**Project #20-019  
Homestead  
Located at approximately 607 West 200 North**

**REPORT SUMMARY...**

<i>Project Name:</i>	Homestead
<i>Proponent / Owner:</i>	Brent Skinner / 200 North Land Holdings LLC / Direct Homes LLC
<i>Project Address:</i>	607 West 200 North
<i>Request:</i>	Design Review Permit
<i>Current Zoning:</i>	Mixed Use (MU)
<i>Type of Action:</i>	Quasi-Judicial
<i>Hearing Date</i>	April 23, 2020
<i>Submitted By:</i>	Russ Holley, Senior Planner

DATE: May 5, 2020  
FROM: Russ Holley, Senior Planner  
SUBJECT: **Homestead Mixed Use Project**

Phase 3

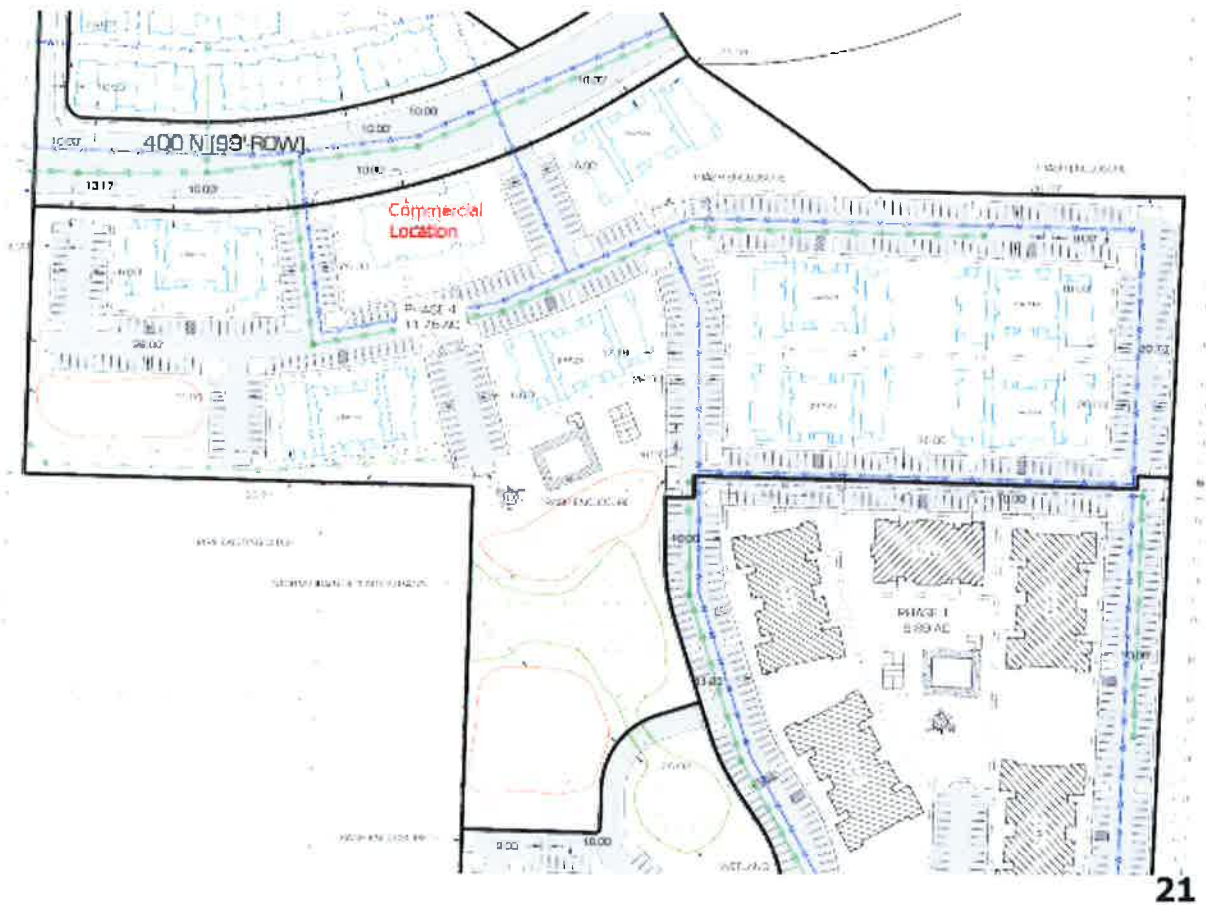
12. The Phase-3 (60-plex) building south elevation shall mimic the north (primary entrance) façade for building orientation compliance with the LDC.
13. Building materials and compositions shall match the submitted elevations and the Phase-2 townhomes shall have fiber cement board in areas labeled as "lap siding"

## SITE PLAN

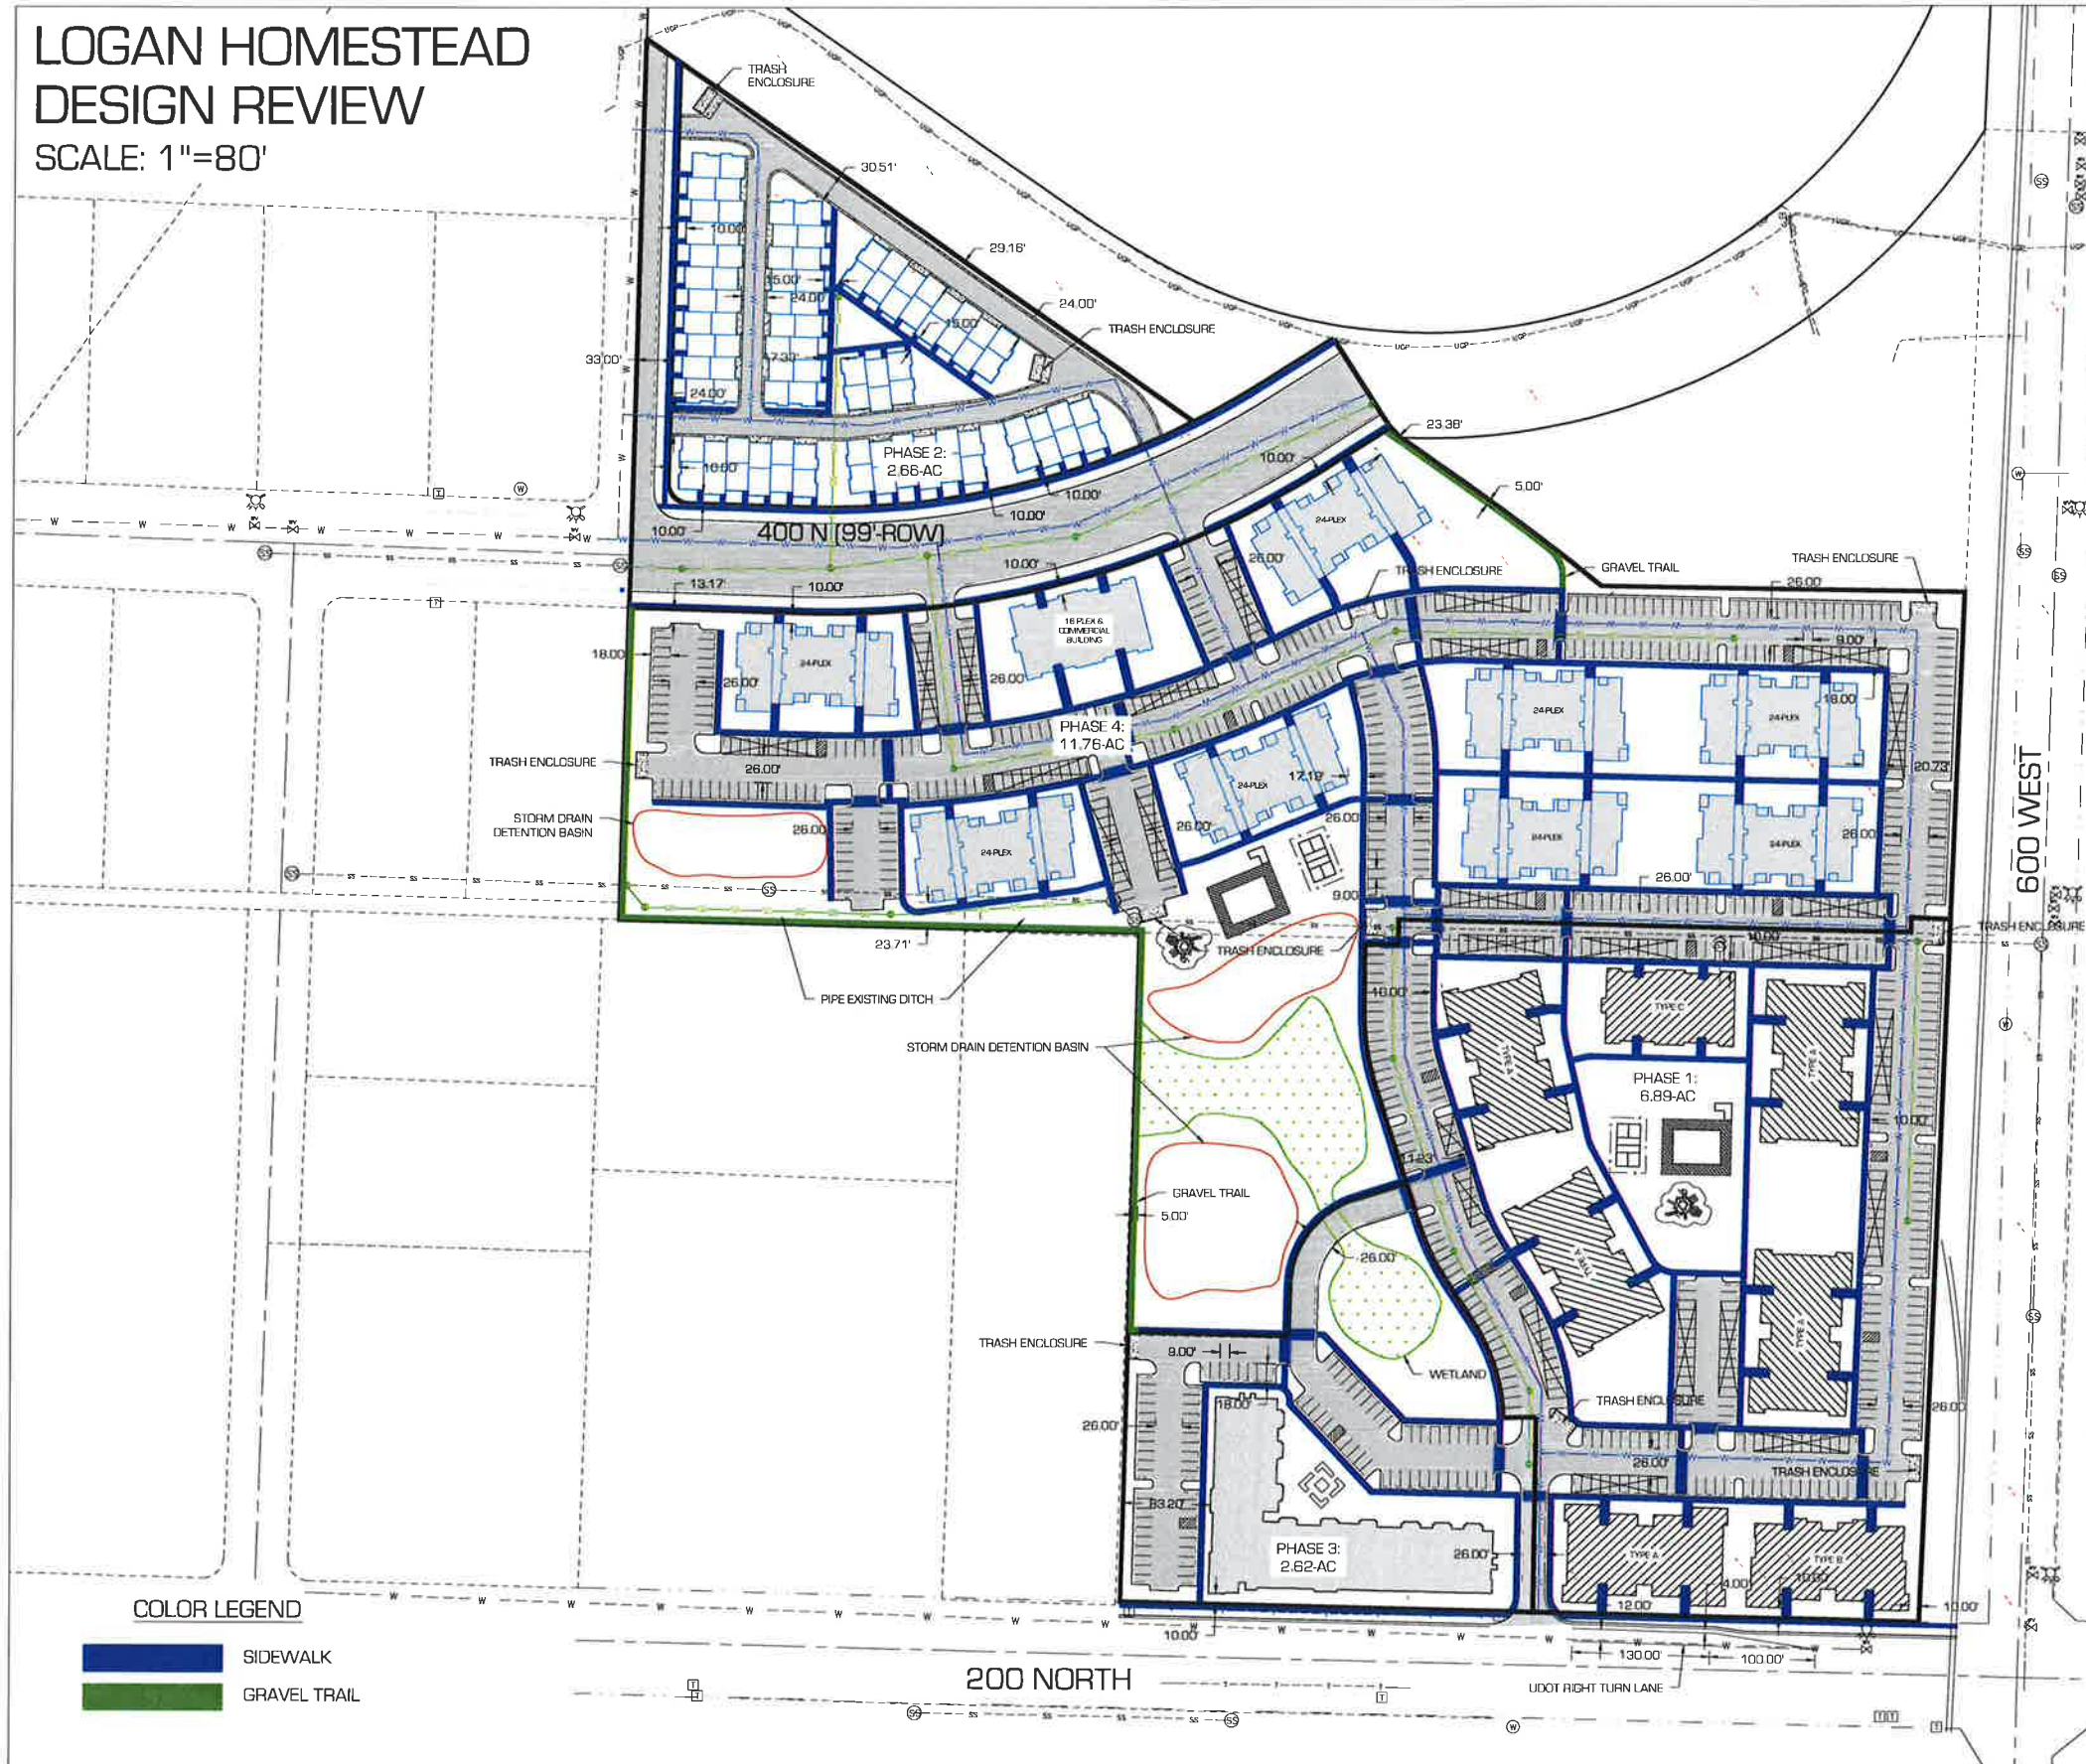
- The west access to 400 North from the south is not acceptable as shown. This needs to align with 800 West from the north or be shifted approximately 200 feet further to the east.

- The accesses from the north and south developments to 400 North shall align with each other at 400 North.
- Provide private water utility agreement for all interior water main lines and sewer lines.

- *Fencing/barrier around the project for safety, security and buffering. Western and eastern border in particular. What is the appropriate material, design etc. We have discussed several options for fencing. There is a firm belief that we would want something that is a visual barrier on the West side of the property. There is discussion as to placing a non-visible barrier on the East side as we have been requested by some representatives of Logan city to allow for visual of our project from 6<sup>th</sup> west.*

- *Street connectivity through the project site vs parking lot connectivity through the site. Tradeoffs for both options, why is one better than the other? Which is better can be debated, but our management team likes how we have set it up as is allowing for the additional overflow stalls. They are willing to place speed barriers and other things through the site to help with any safety concern.*

- *Pedestrian walkability/safety throughout the entire project site We are and will work with city staff on safe crossings. We feel very comfortable with the walkability within each area and are working to address parking lot crossing.*

- The applicant's proposal to run a sidewalk along the future 400 North alignment has some alignment issues. *That was a theory thrown out based on the neighbors comments* The railroad spur property, as currently configured, does not align with where the new road/sidewalk should go and would require immediate property purchases from Spendlove/mobile home park to align with the existing 400 North intersection position and future 400 N extension. The intersection at 400 N 600 W would require extensive upgrades (ADA, curb, gutter, new crosswalks, etc.) to be done immediately. Who pays for all of this right now to do it correctly or is this a sidewalk the weaves out of alignment with temp crossing improvements (not safe with liability issues) that will be all torn up in a few years when the 400 N extension project is fully funded and completed.

- The 200 North 600 West intersection is really the only viable pedestrian link to the existing neighborhood. What improvements are needed to make this safe and convenient. How do the interior building tenants conveniently access this southeast corner of the project site. *We are working with UDOT, Bill Young and the railroad to determine the crossing requirements.*

- Phase 3 building orientation focuses inward with the façade along the street lacking some architectural features. Four-sided architecture needs to be reviewed. *This will be addressed*
